Project No. 12091-01

Subject: Preliminary Geotechnical Evaluation and Response to City Review Comments for Proposed San Pedro Distribution Center, 1599 W. John S. Gibson Boulevard, Los Angeles, California

5.0 RESPONSE TO CITY REVIEW COMMENTS

SHEET
4 of 5

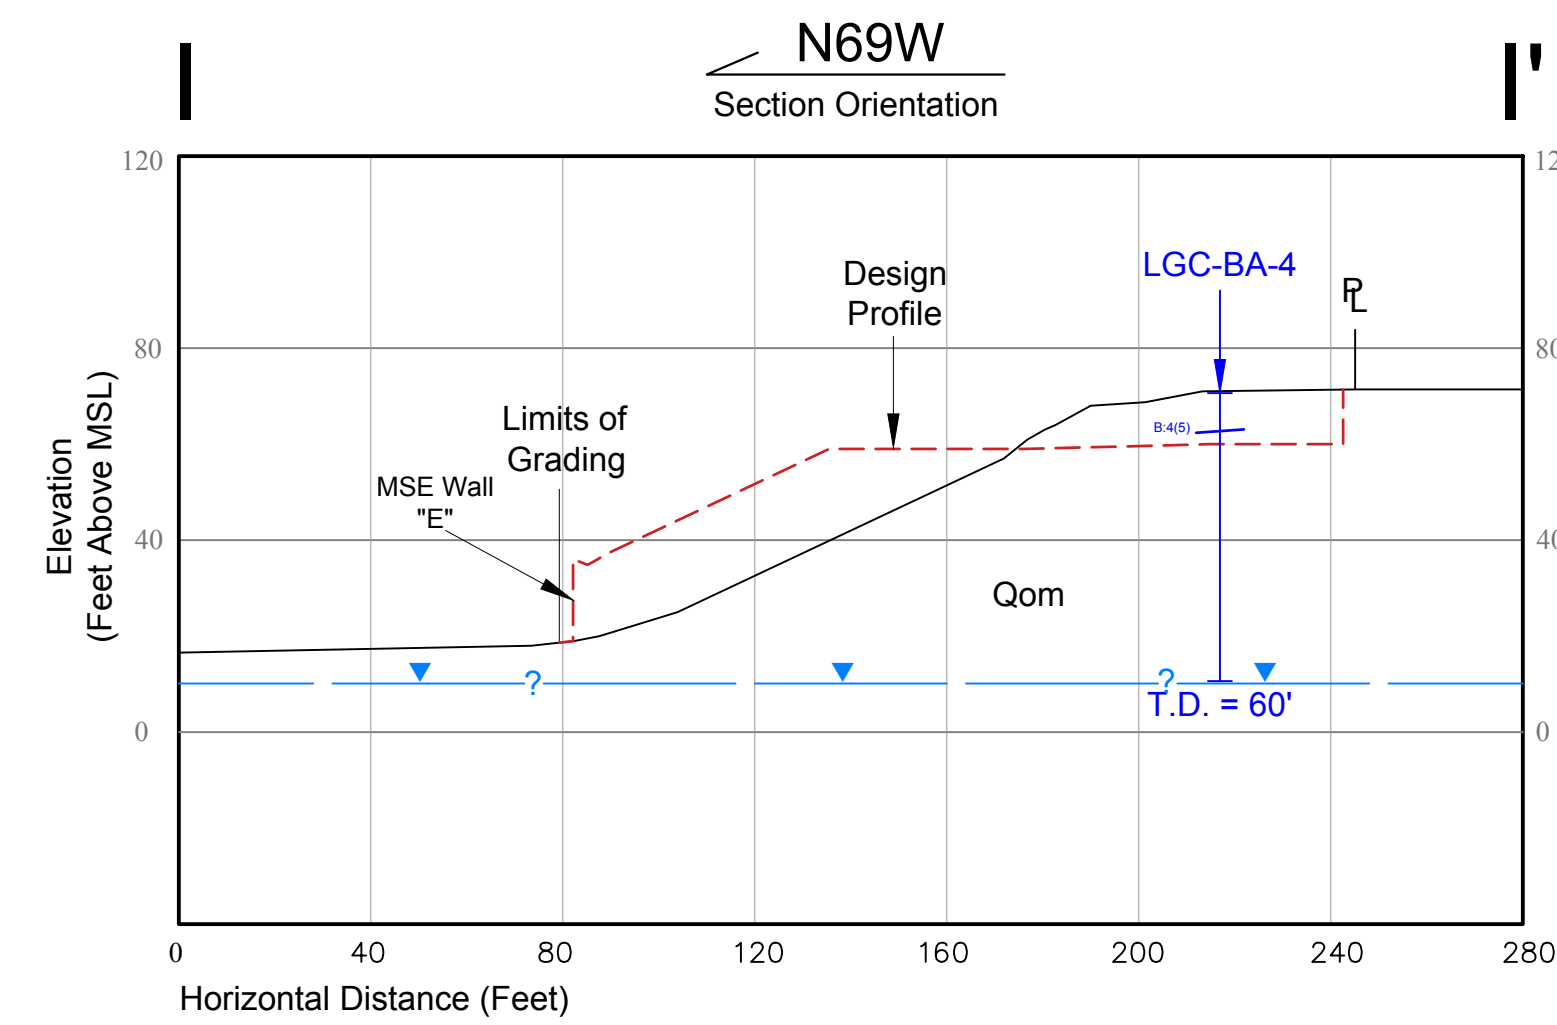
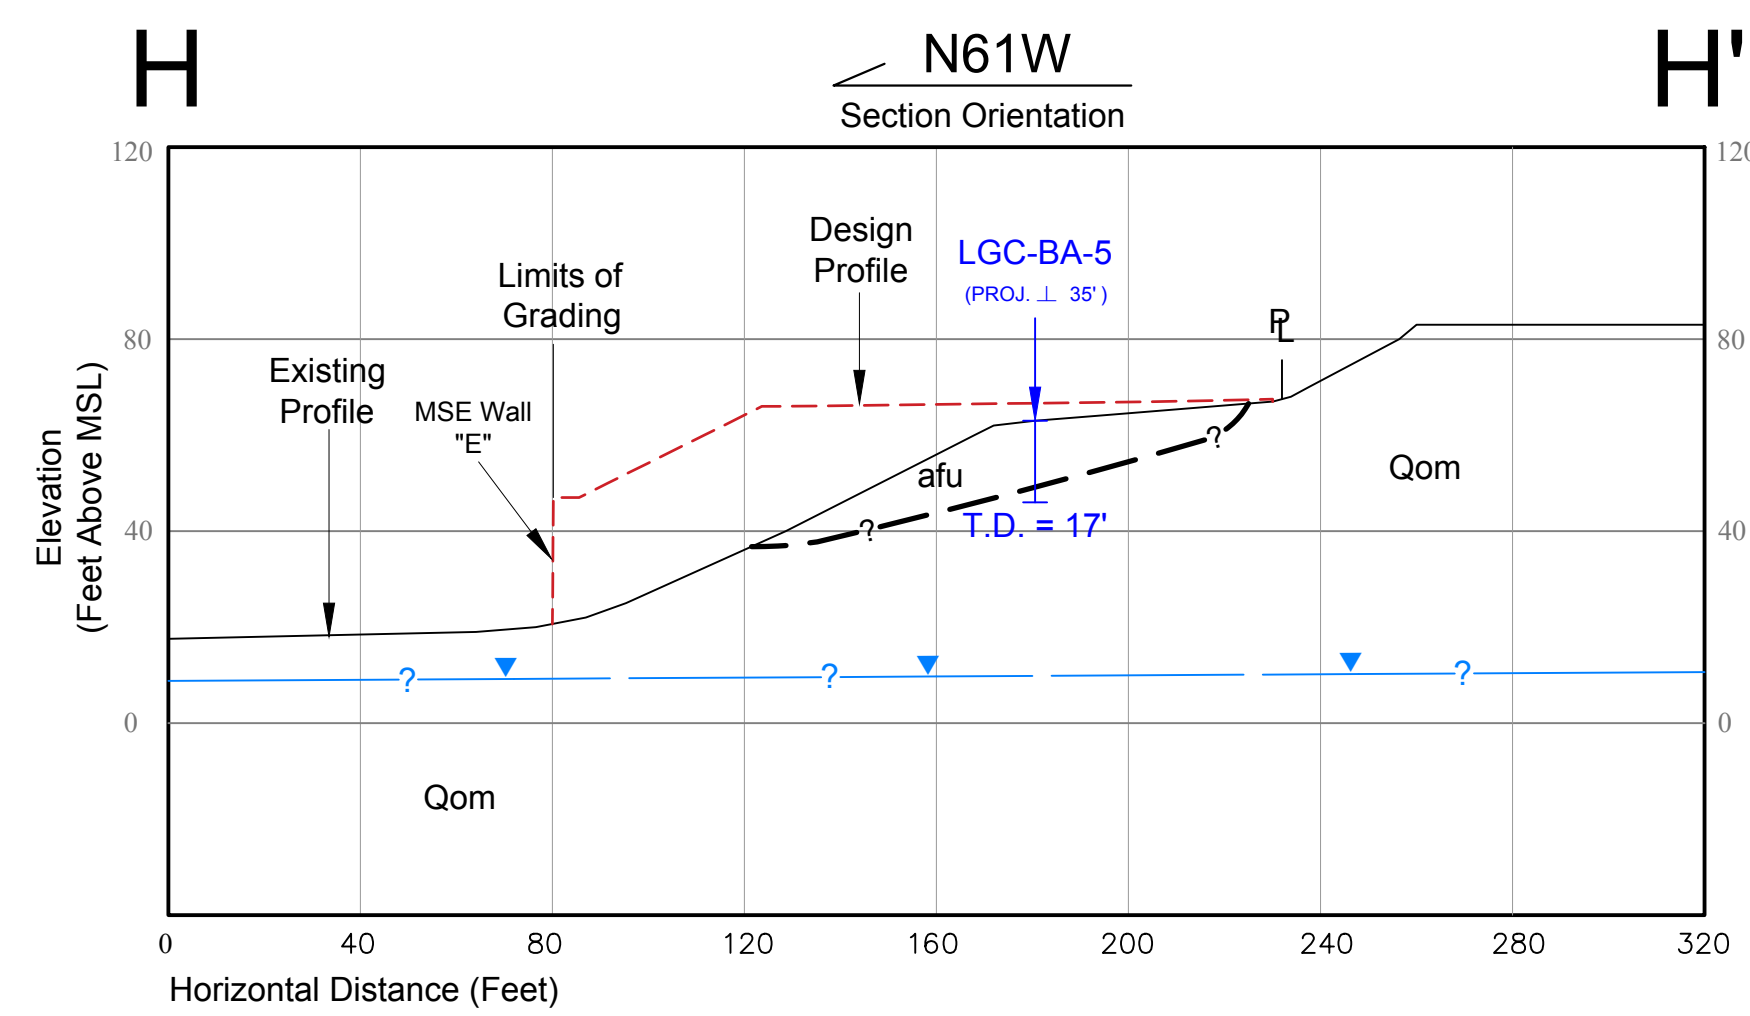
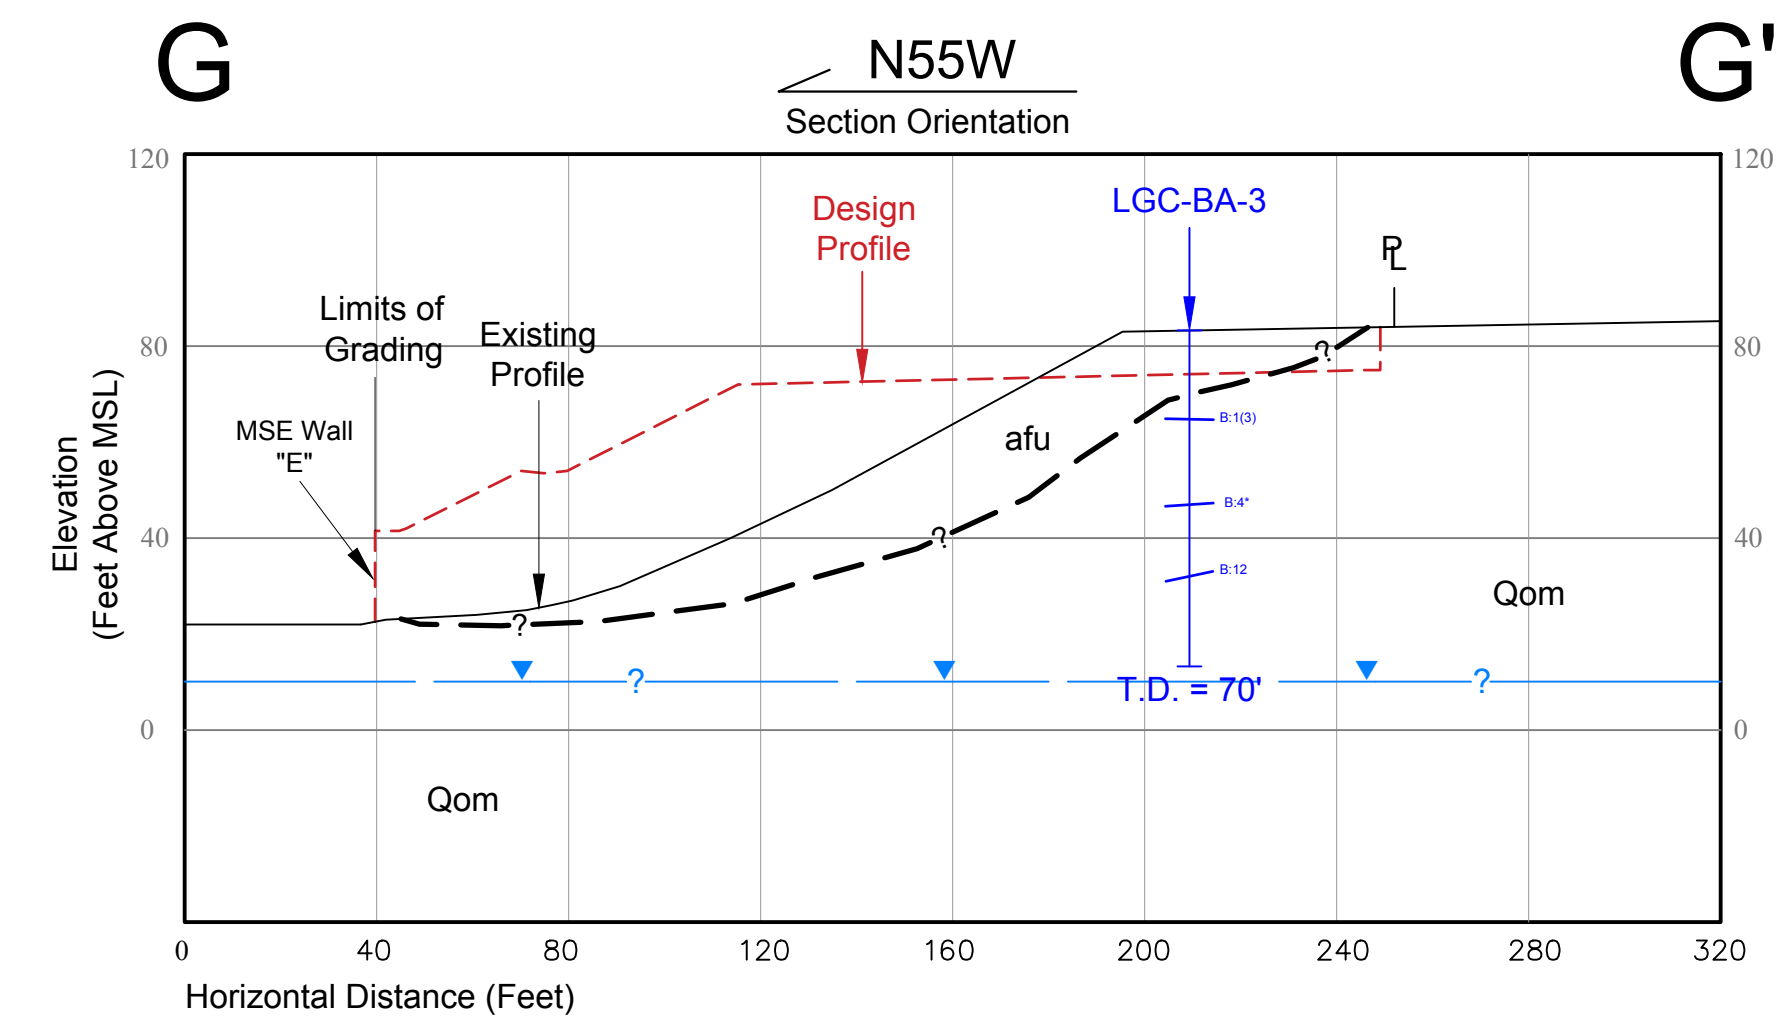
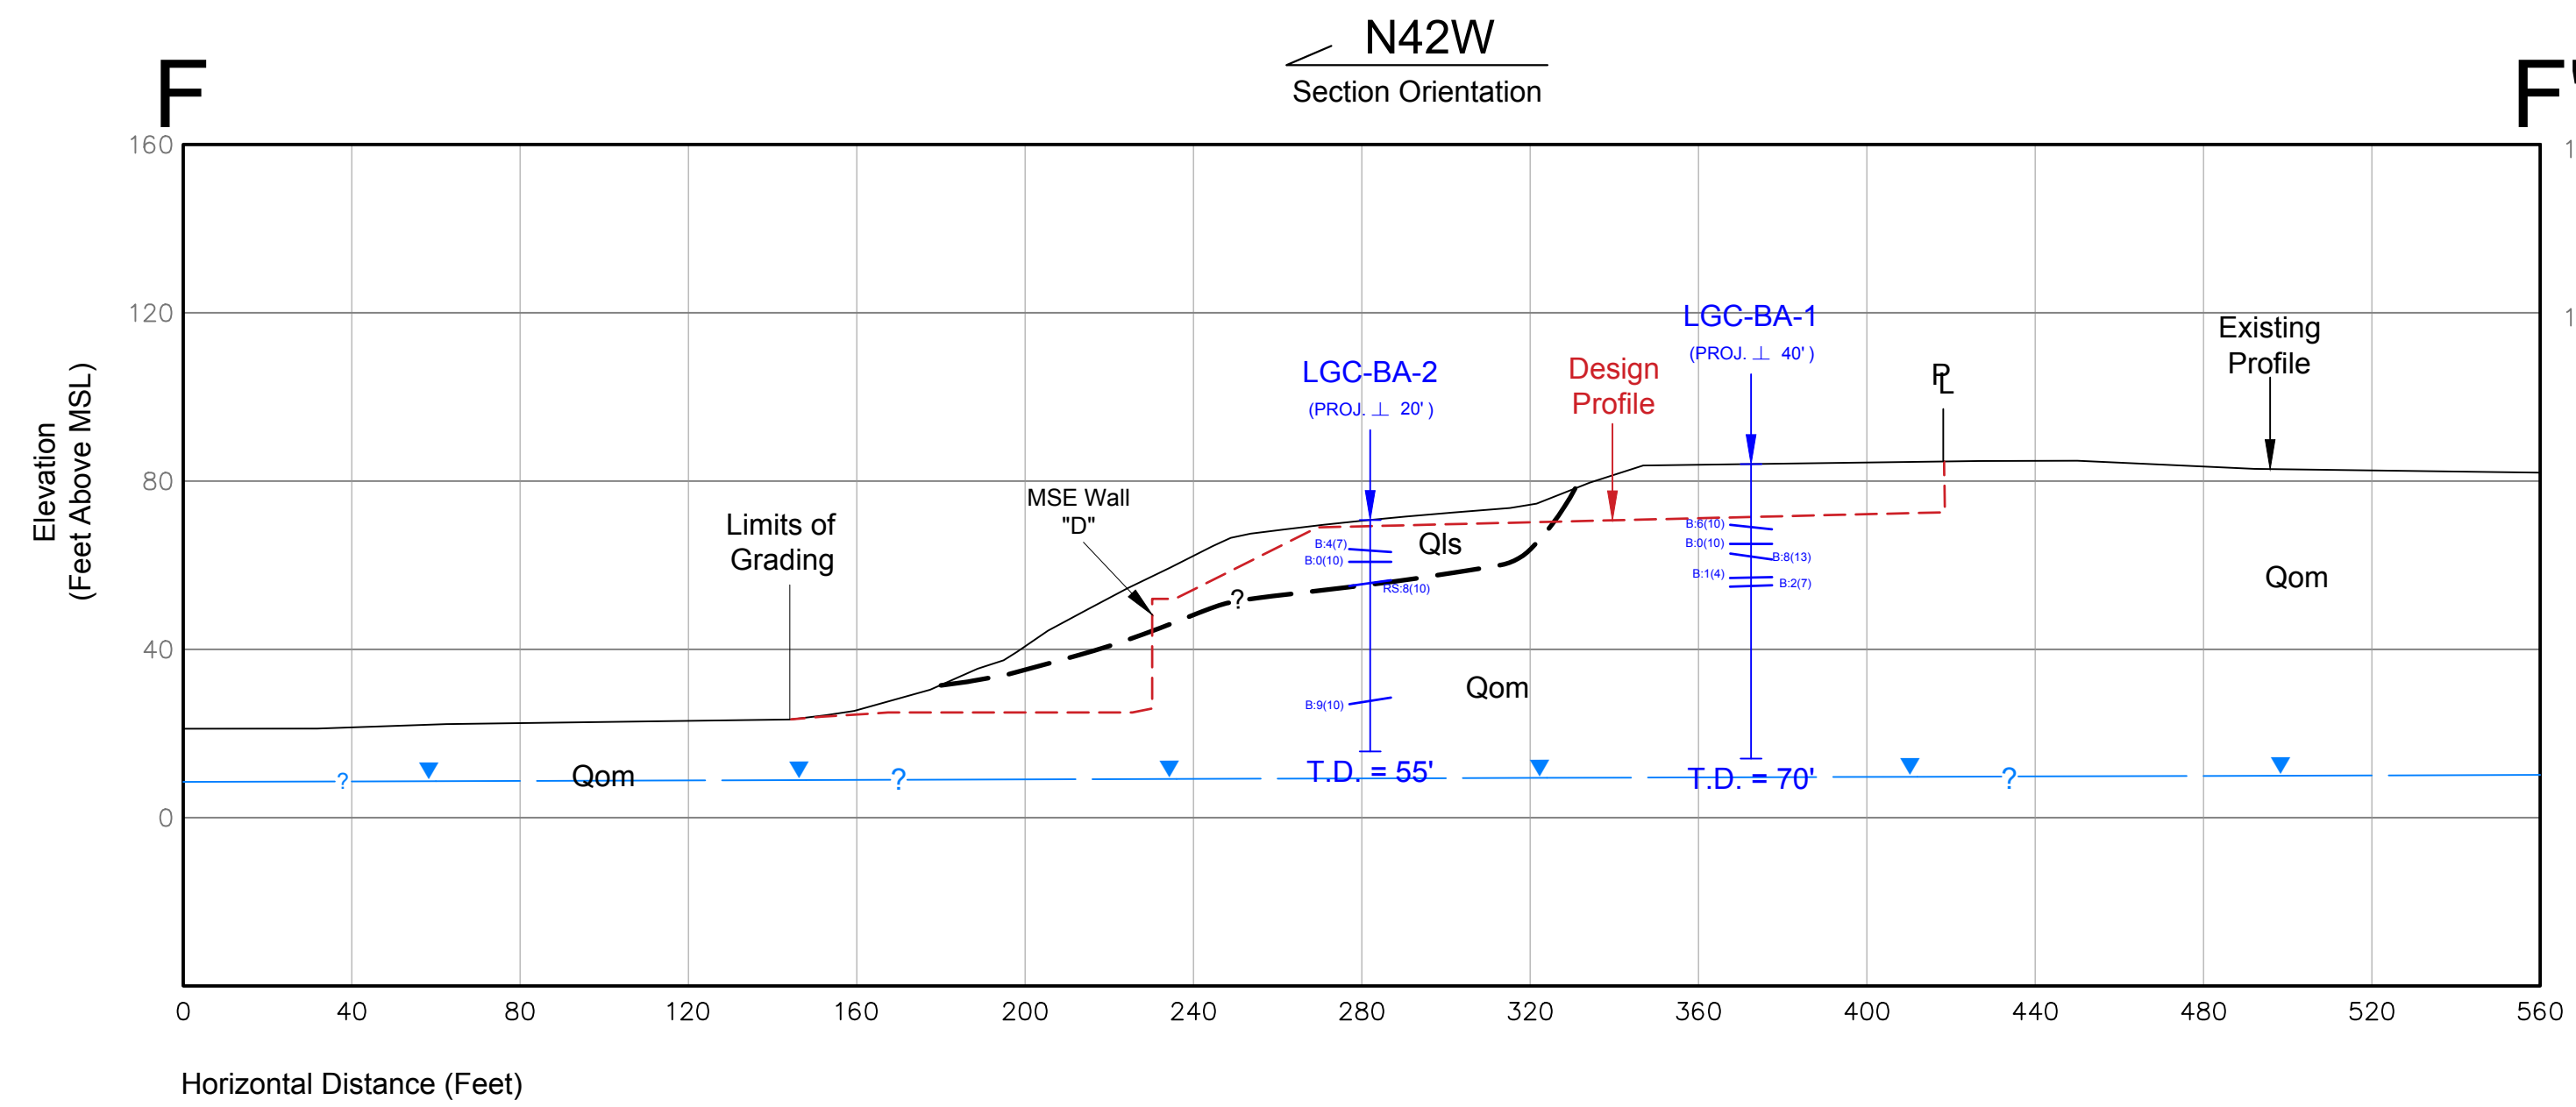
“Provide a geologic map and cross sections that are based upon conceptual grading or site development plans, to illustrate all proposed and existing contours relative to the planned grading and/or construction, along with all off-site slopes and conditions that could adversely affect the stability or safety of the site (7006.3.2). The geologic map and cross sections shall depict the top and bottom of slopes; lithologic contacts; bedding attitudes; locations of slumps, landslides, or faults relative to the subject site; existing and proposed topographic profiles; existing and proposed structures; and, required Code setbacks. (7006.3.2)”

“Provide geological cross sections illustrating existing and proposed grades and structures through the highest, steepest and geologically critical slopes.”

Refer to the attached Geotechnical Map and Geotechnical Cross Sections (Sheets 1 through 5). No building structures are planned for the site.
